## Explanation of Significant Differences (ESD) Summary Sheet

Site Number: 738003  
Name of Site: Volney Landfill  
Town and County: Town of Volney, Oswego County

# Explanation of Significant Differences

## VOLNEY LANDFILL SITE

Figure  
16  
Project No.  
132.165

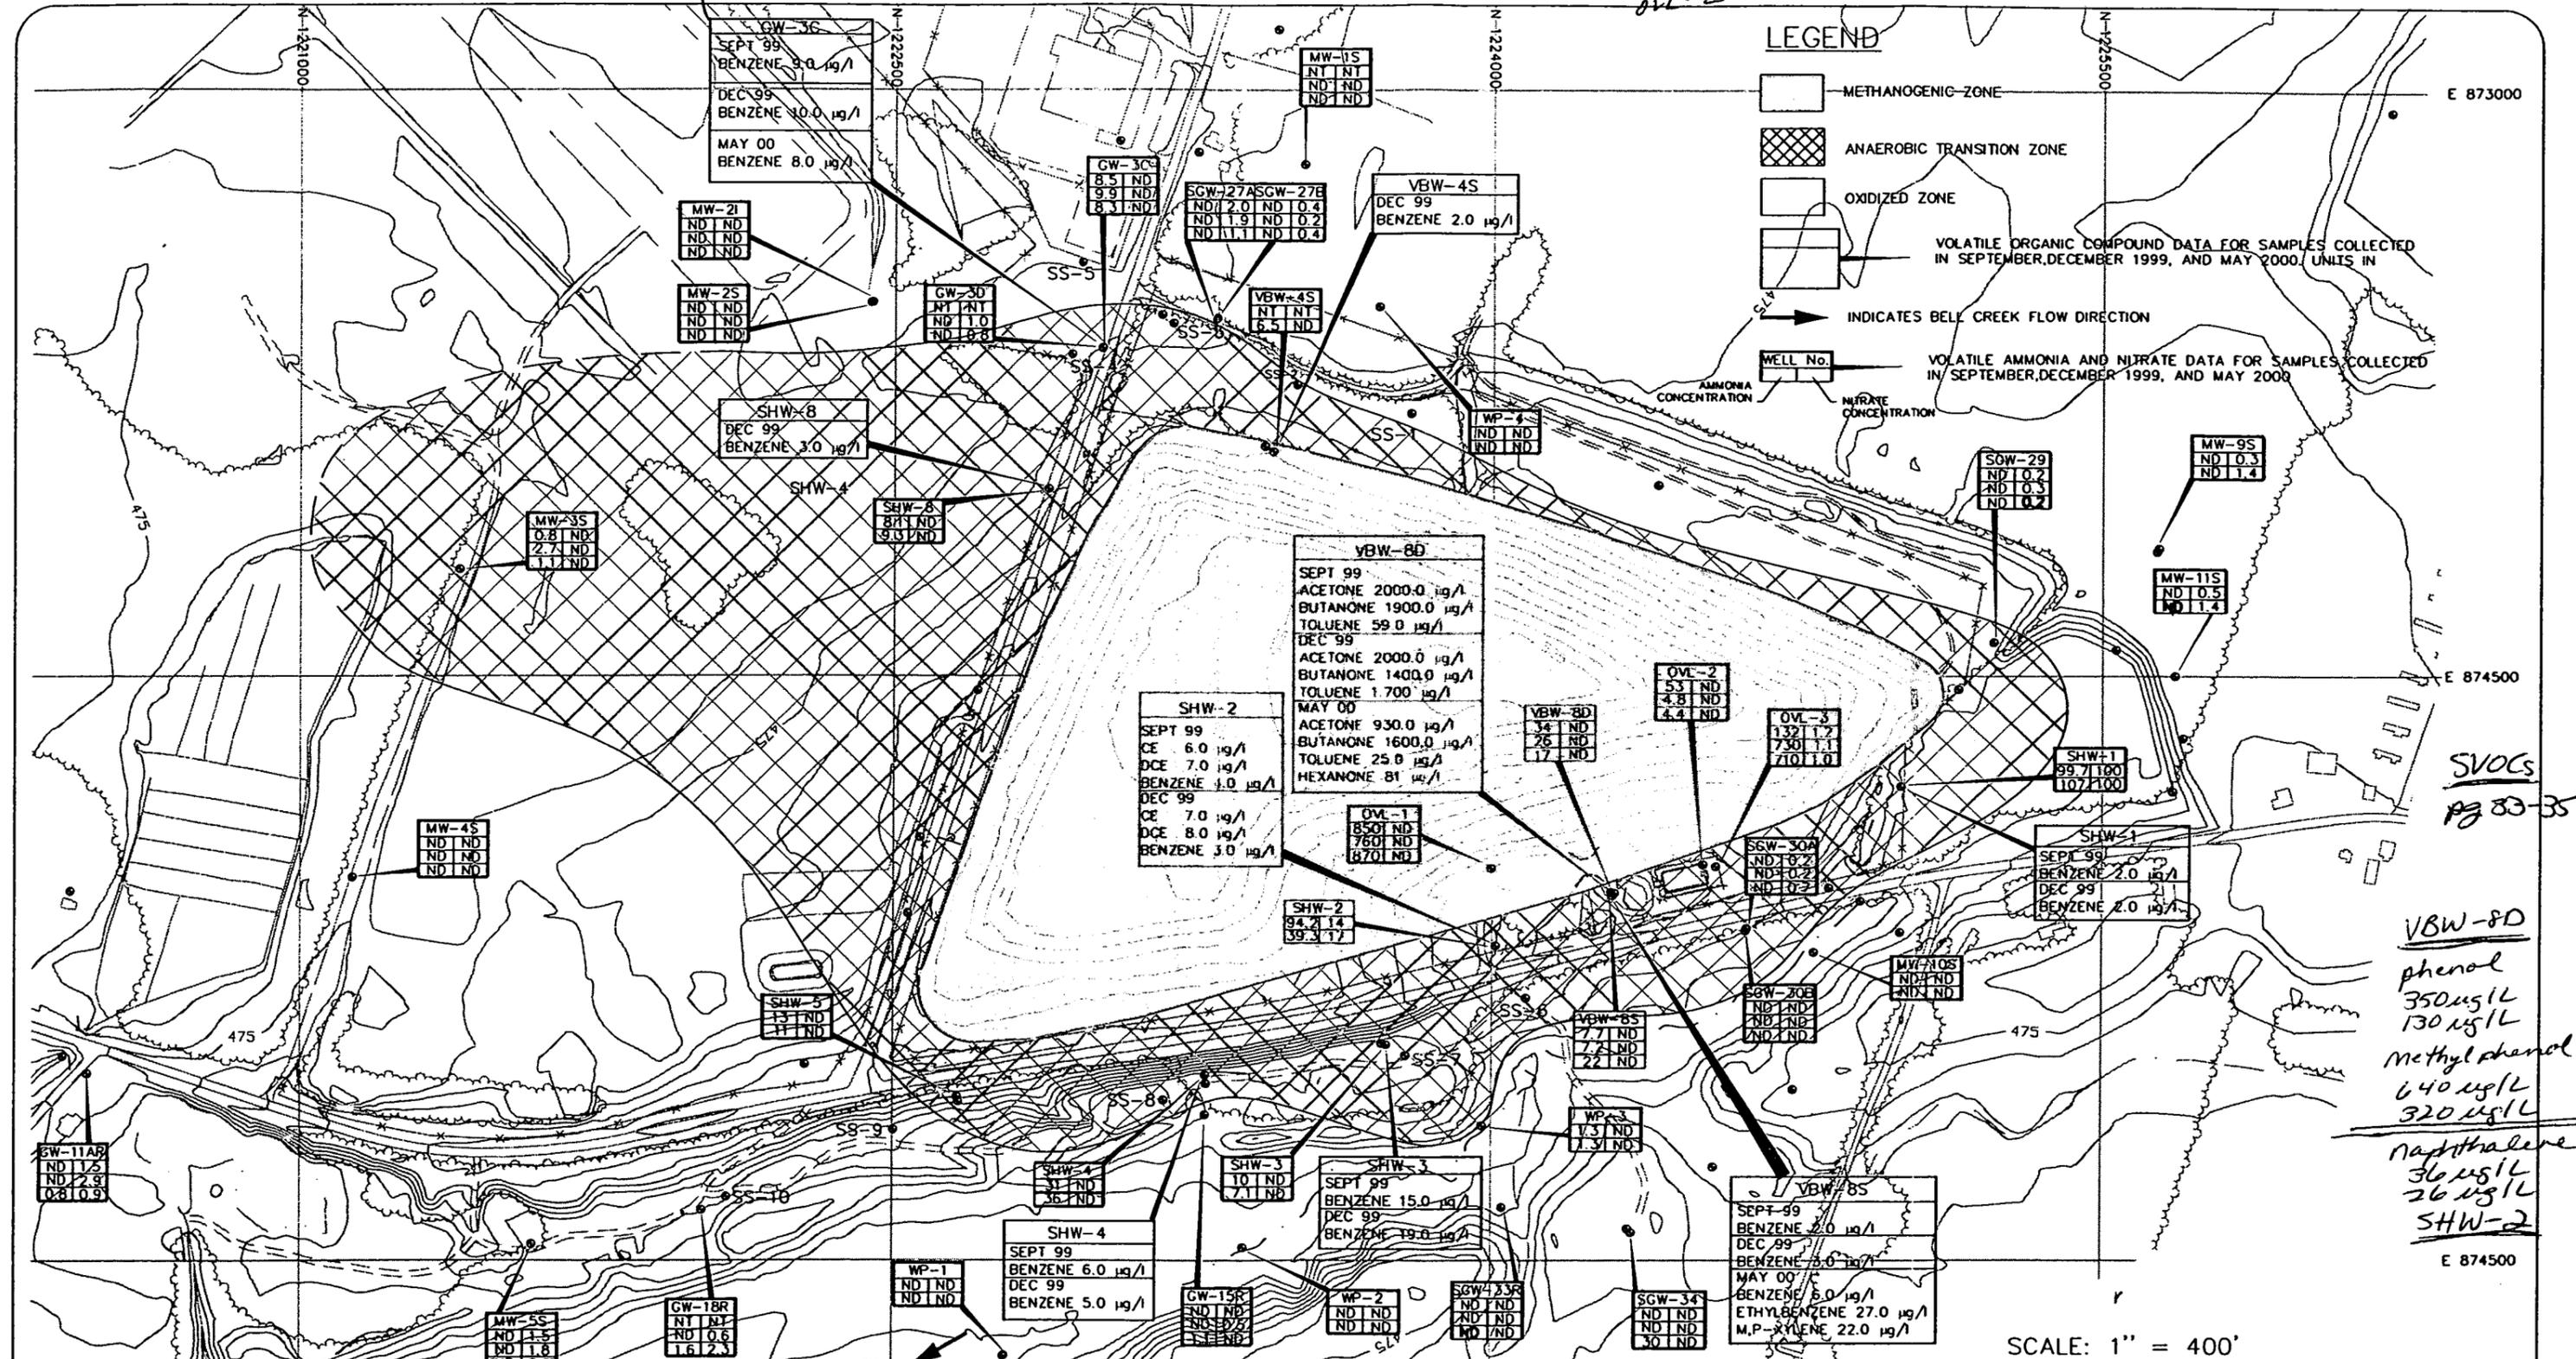
chloroform 10 ug/L

Leachate sample  
OVL-1  
OVL-3 ) page 30  
OVL-2

Metals  
pg 33-35
